# MANDATORY SERVICE BULLETIN

## MSB D4-075/2

Air induction system.

### WI-MSB D4-075

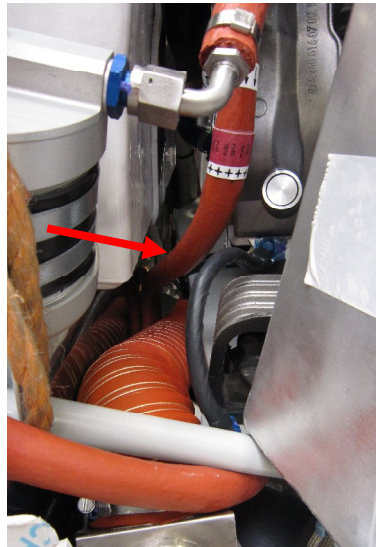
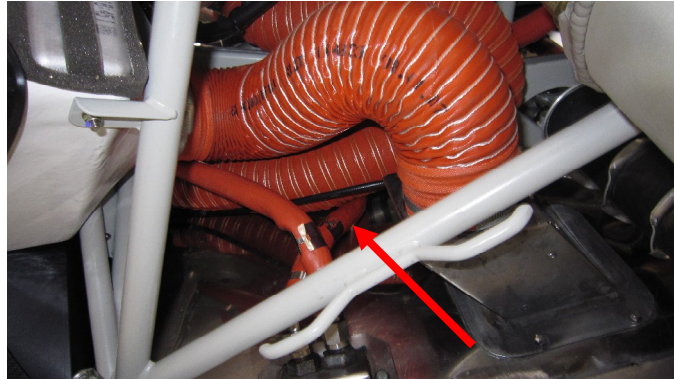
8. Make sure that the fuel return line- and turbocharger hose routing is according to the following pictures. Torque worm-drive clamps with 5,5 Nm (4 ft lb).

9. Install Clamp D4D-7166-00-91 and RSGU1-65 with bolt nut and washer according to the following picture.

Position of clamp 140 mm (6 in) from centre of engine mount cut out.
